**TOWN OF OCEAN RIDGE
PLANNING & ZONING REGULAR MEETING
AGENDA**

To:	Planning & Zoning Board Members
From:	Corey O’Gorman, Town Planner
Meeting Date:	September 15, 2026
Subject:	30 Oceanview – Development Plan Review

PLAN REVIEW REPORT
30 Oceanview Drive
02/16/2026/~~Revision 03/25/26~~
~~Revision 05/12/26~~
~~Revision 6/25/26~~

Subject: Site Plan Review Comments
30 Oceanview Drove (DPR)
CAS Project No. 08-26-008

SITE PLAN
SCALE = 1/8" = 1'-0"

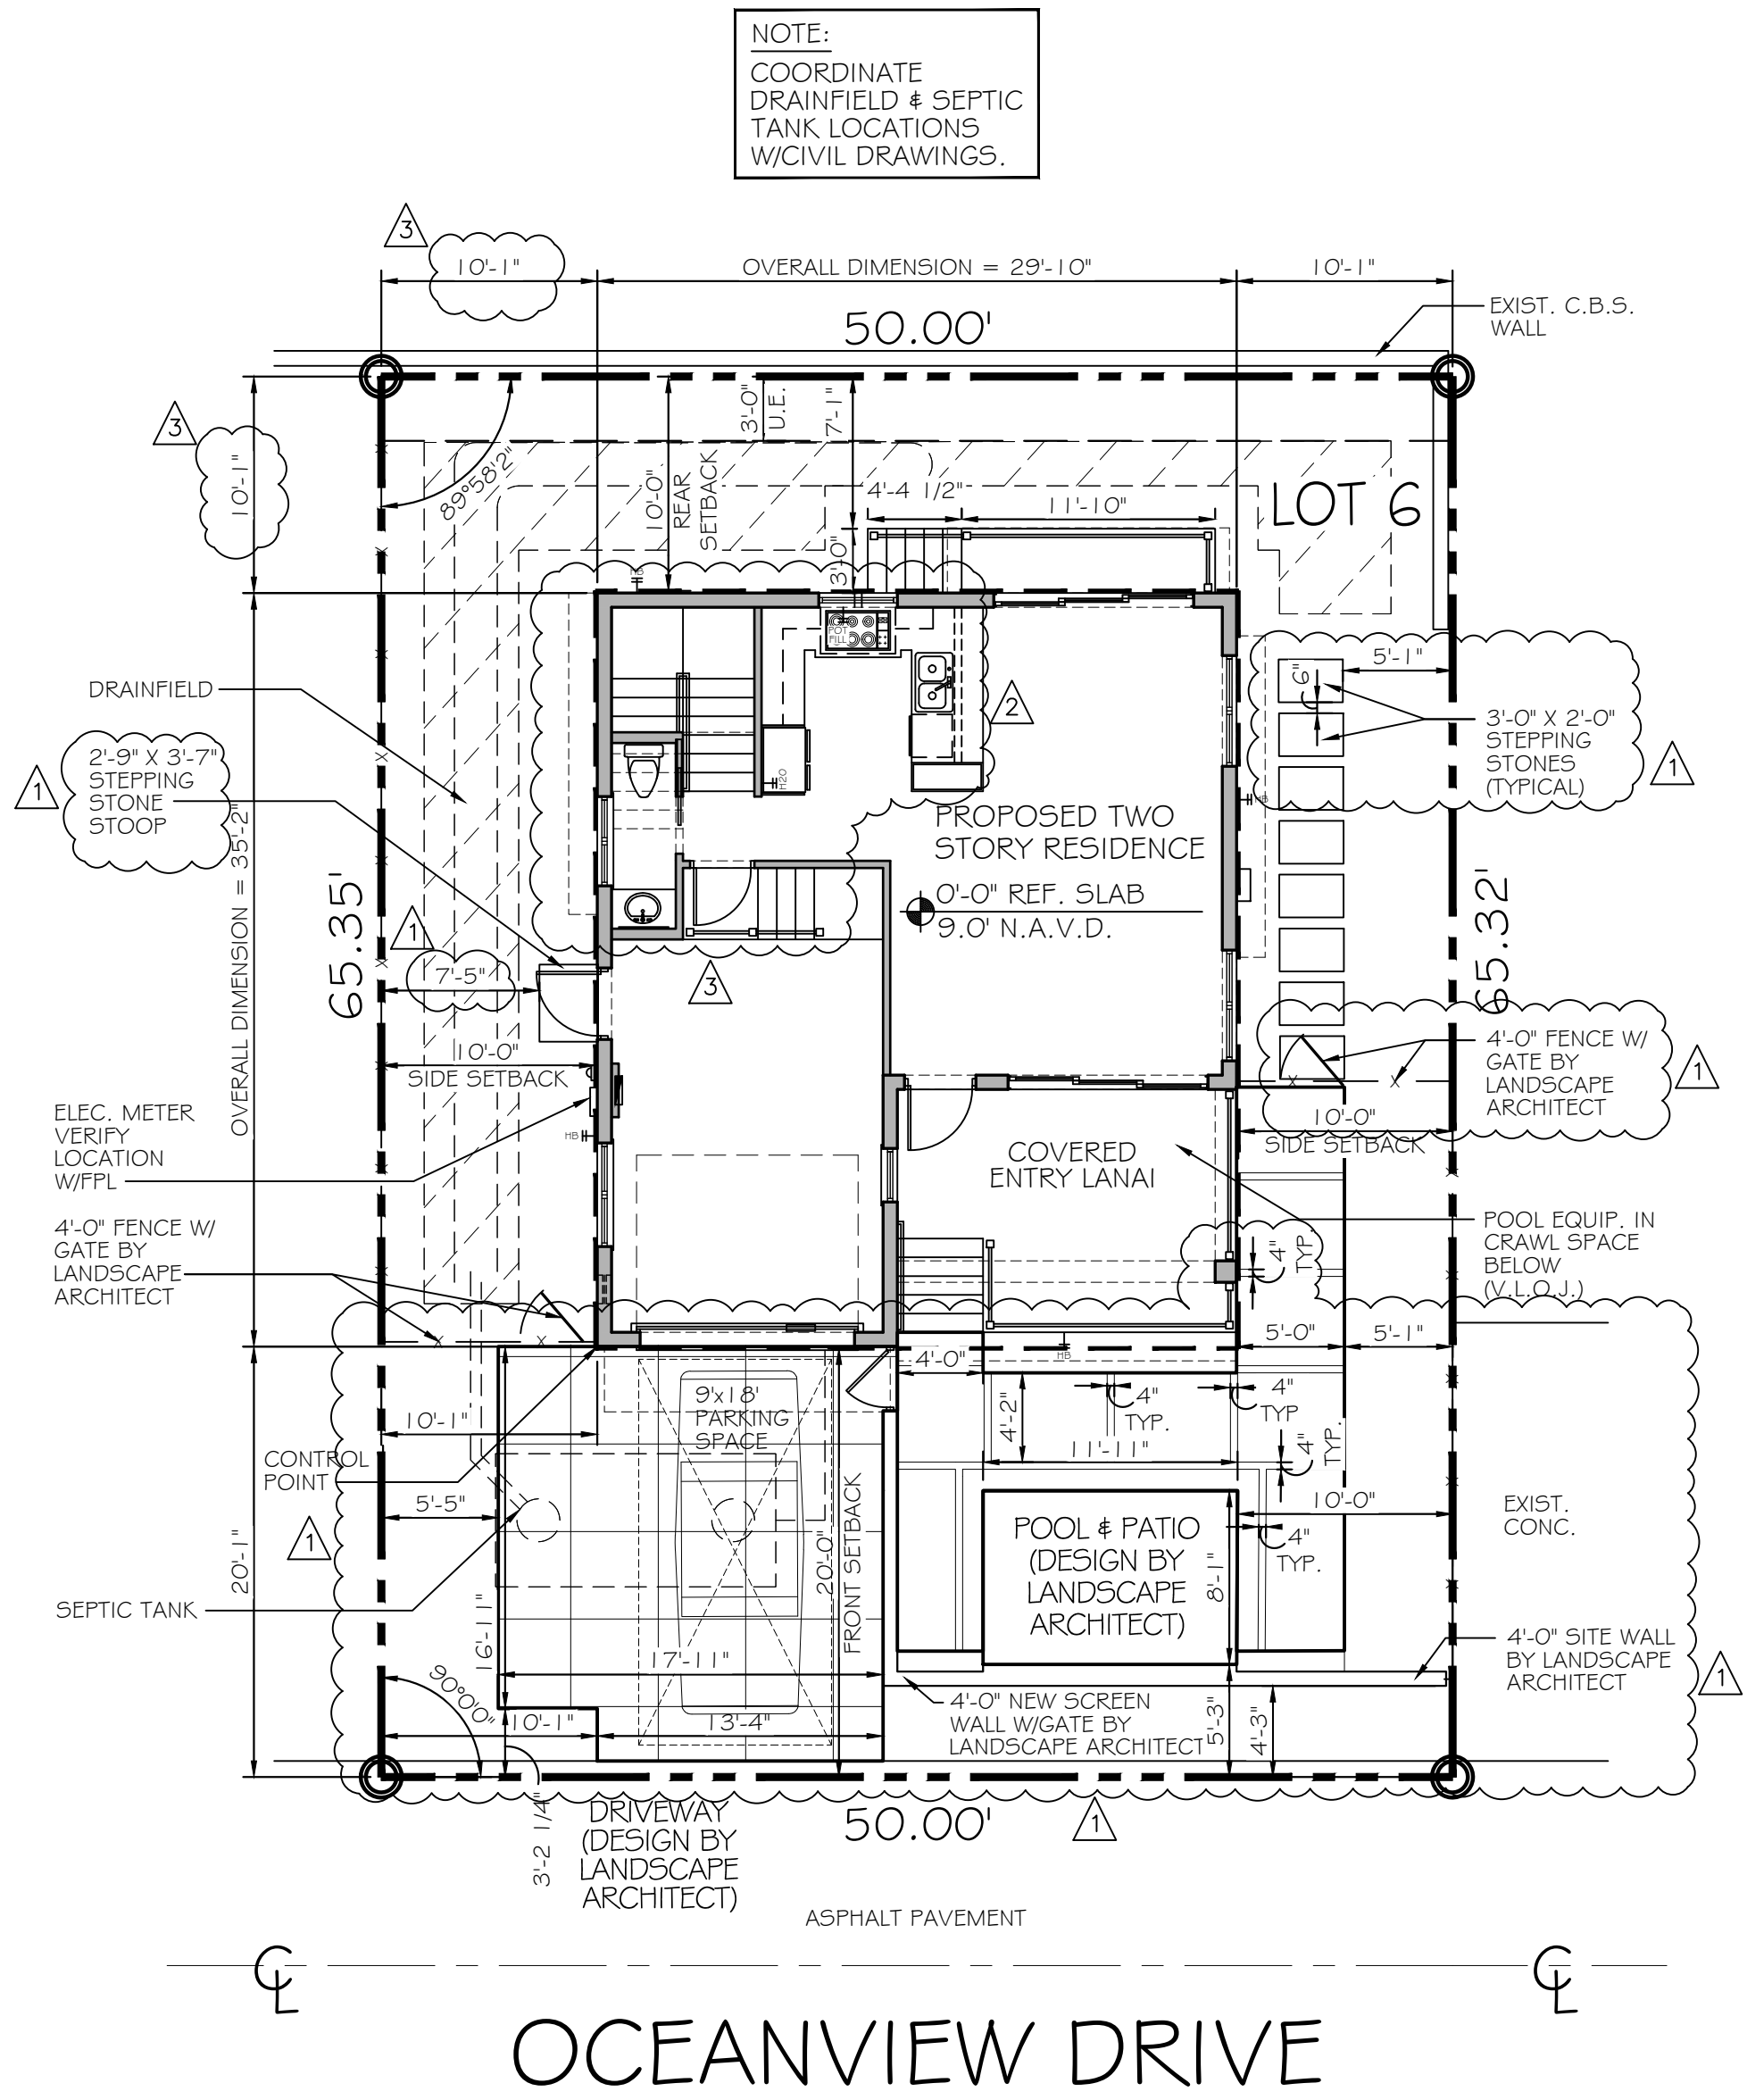
Comment: Please revise the plans to comply with the minimum side setback and/or specify what code section permits the proposed encroachment. ~~The response to this comment is that the encroachments which include interior living space are architectural features. Based on analysis of the Town Code in consultation with the Town Attorney these encroachments are not architectural features but are part of the principal structure as defined in Section 1-3 of the code and as such must comply with the minimum 10' setback in accordance with Section 64-3. Please revise the plans to delete these encroachments and comply with the 10' setback.~~

~~**Comment:** Please revise the site plan sheet ASP-1 to show the exterior space with the 9' x 18' minimum dimensions to comply with the exterior space requirements and to comply with the requirement to provide one (1) parking space. **Comment addressed.**~~

~~**Comment:** Please dimension the swimming pool setbacks on ASP-1 to comply with this town code. **Comment addressed.**~~

~~**Comment:** Please revise sheet ASP-1 to show the height of any and all proposed walls or fences. **Comment addressed.**~~

Comment: Please revise sheet ASP-1 to show the setback for the driveway at the property line to comply with this code section. **Comment addressed.**

Comment: Please provide the dimensions for the proposed driveway, unenclosed and uncovered decks, parking areas, steps, and stoops to ensure compliance with this town code. **Comment addressed.**

The architect's response: "The encroachments have been removed. To provide an architectural feature, the plans were revised. The architectural feature will be constructed under the roof overhang as a standard over frame having a stucco finish at the second floor only, providing our decorative gable end feature." In addition, the "architectural feature" is described as a "standard over frame having stucco finish at the second floor only" and is constructed "under the roof overhang".
